Sub: Modification Sheet No. RDSO/2018/EL/MS/0468 (Rev. '0') dtd. 06.02.2018 for modification in existing hotel load scheme by removing irrelevant protections provided in WAP-7 locomotives.

MODIFICATION SHEET NO. RDSO/2018/EL/MS/0468 (REV. '0') dtd. 06.02.2018

Modification in existing hotel load scheme by removing irrelevant protections provided in WAP-7 locomotives.

Figure – 1

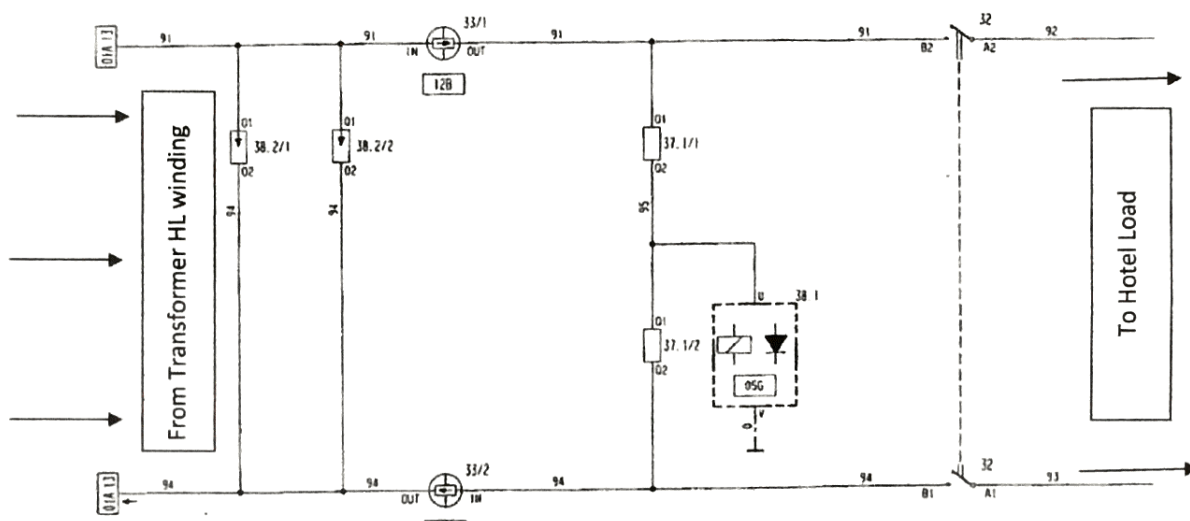
some essential protection were provided for HL winding through the under mentioned components. The scheme is shown in Figure – 1.

Item. No.	Description	Purpose
32	Contactor for hotel load	Main input Contactor
33	Current Sensor for Hotel Load Supply	Over Current Protection during short circuit condition
35	Socket Hotel Load Supply	Supply for connecting HLC in Power Car
37.1	Resistor for Earth Fault Detection Hotel Load	Earth fault detection on input side
38.1	Earth Fault Relay for Hotel Load	
38.2	Surge Arrestor for Hotel Load	Surge Protection

Figure – 4

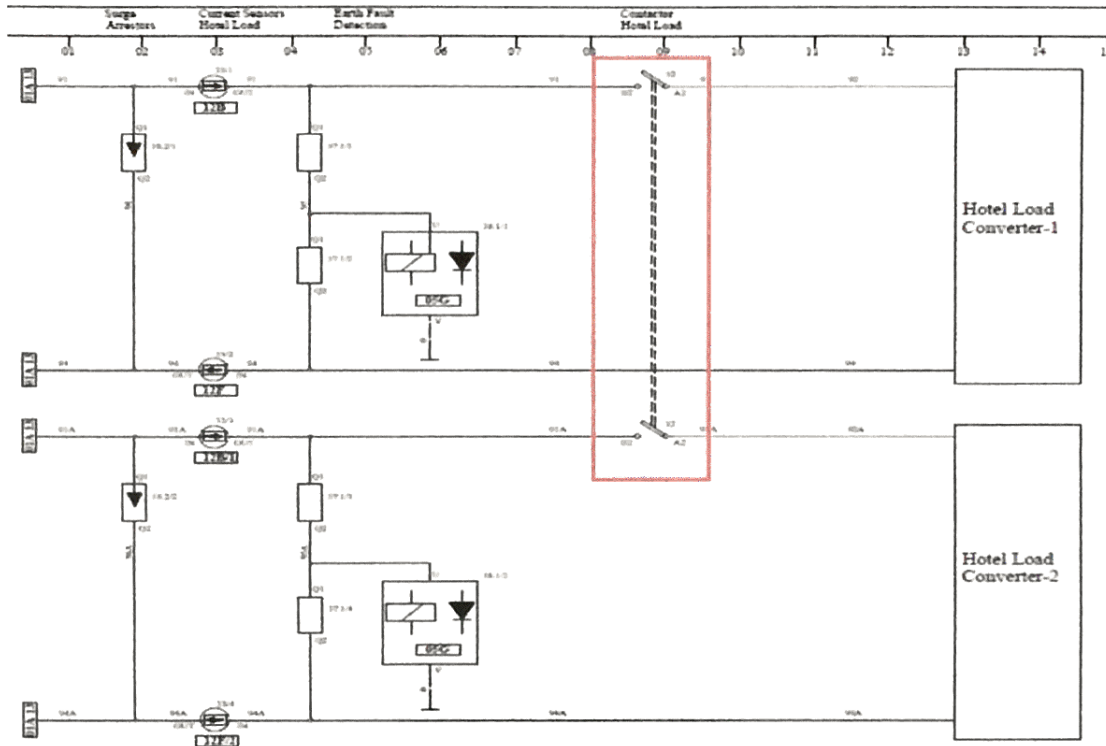
- 4.0 The entire protection scheme as followed in previous single HOG winding was also provided in each of dual HOG windings also. However in this arrangement, only one phase of each HL winding was provided with contactor (32) as shown in figure-4 below.

- 7.1.1 **Main Contactor (32):** As discussed above, the main function of making and breaking of the circuit is through contactor provided in HLC itself. Therefore, it becomes irrelevant to use additional main contactor (32) in filter block (FB). Hence, in the proposed scheme this contactor shall be eliminated from the circuit.

- 7.1.2 **Earth Fault Protection:** As per specification, the HLC supplied at present by different manufacturer, has been provided with Earth Fault Protection on both (input and output) side of HLC. Hence, Earth Fault Relay for Hotel Load (38.1) provided in filter block (FB) shall be removed from the HL circuit.

- 7.1.3 **Surge arrestor:** This has already been provided by HLC manufactures inside both the HLC. Hence Surge Arrestor for Hotel Load (38.2) provided in filter block (FB) shall be removed from the HL circuit.

Figure – 5: Control Panel provided in Power Car

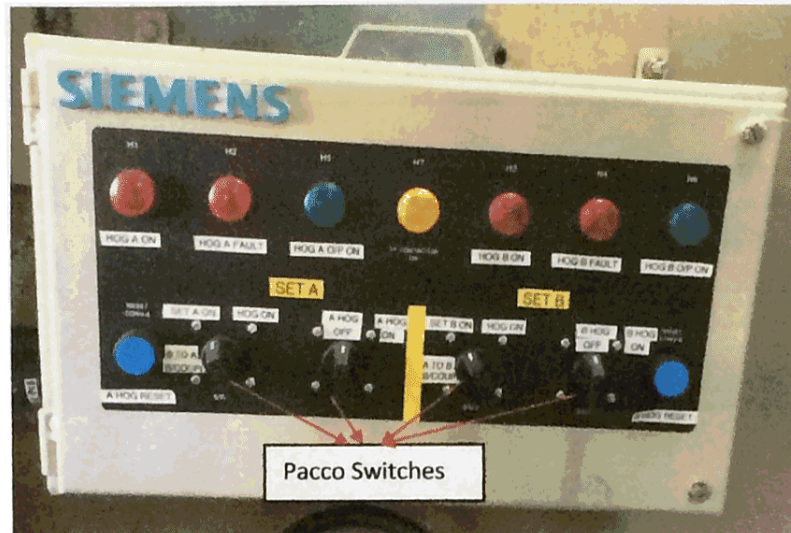
- 6.2 **Pacco Switch:** Control panel for switching OFF/ON control of the Hotel Load Converter has been provided in power cars where it can be controlled through Pacco switches connected through UIC as shown in Figure – 5. Thus, the ON/OFF command is under control of power car.

Ref. Drg No.: 3EHP281101 (01H)			
Hotel Load connection ckt. without 32 and 33 no. Contactor			
DRAWN BY SSE/D&D			
CHECKED BY AEE/D&D			
APPROVED BY Dy.CEE/D&D

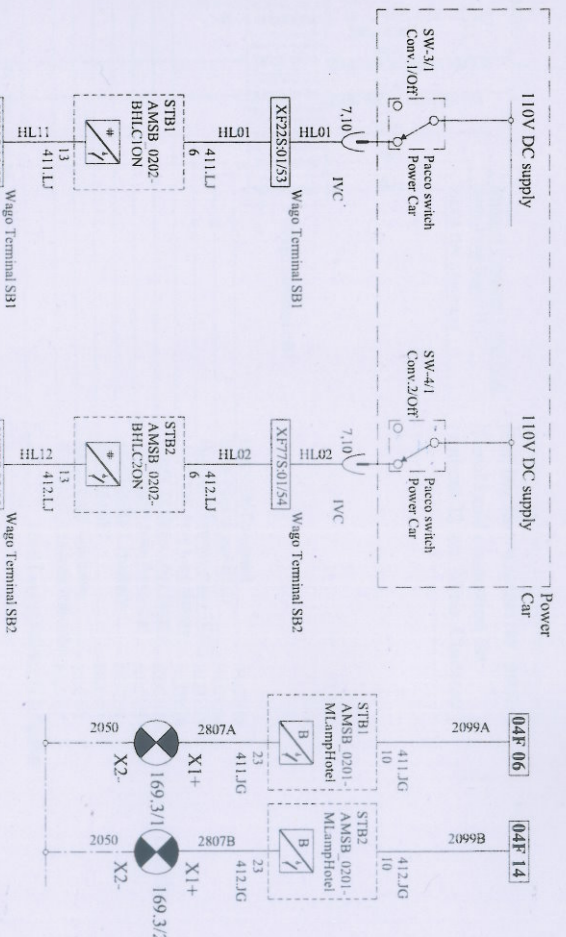
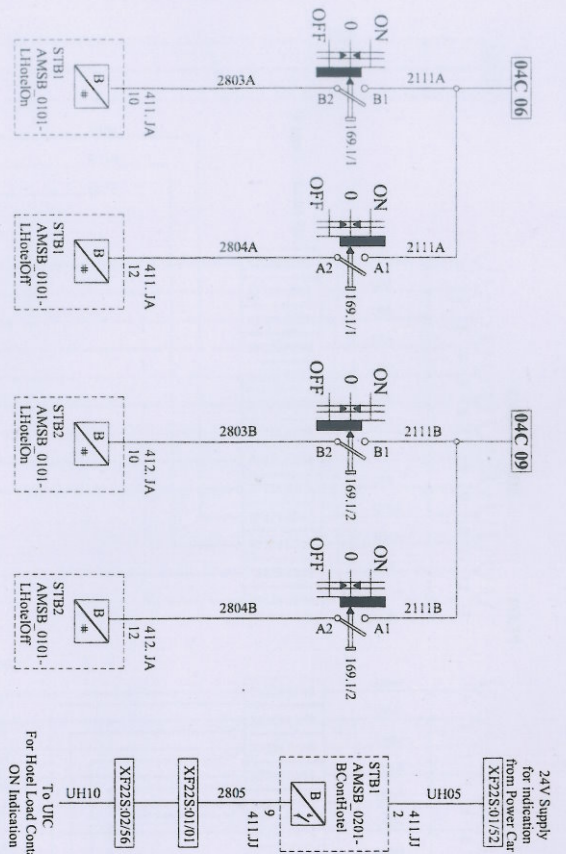
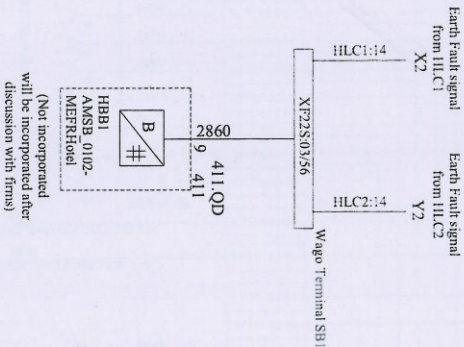
- 7.2 The detailed drawings for Hotel Load connection circuit without 32 no. contactor and 33 no. relay provided in HB panel (CLW drawing No. 3EHP281101 01H & 3EHP281105 05D) have been enclosed as Annexure – 2. Modified UIC-Line Hotel Load 1&2 (CLW drawing No. 3EHP281113 13B) has been enclosed as Annexure – 3.
- 7.3 Modified cable index along with details of cables removed/modified for Hotel Load Converter is enclosed as Annexure – 4.
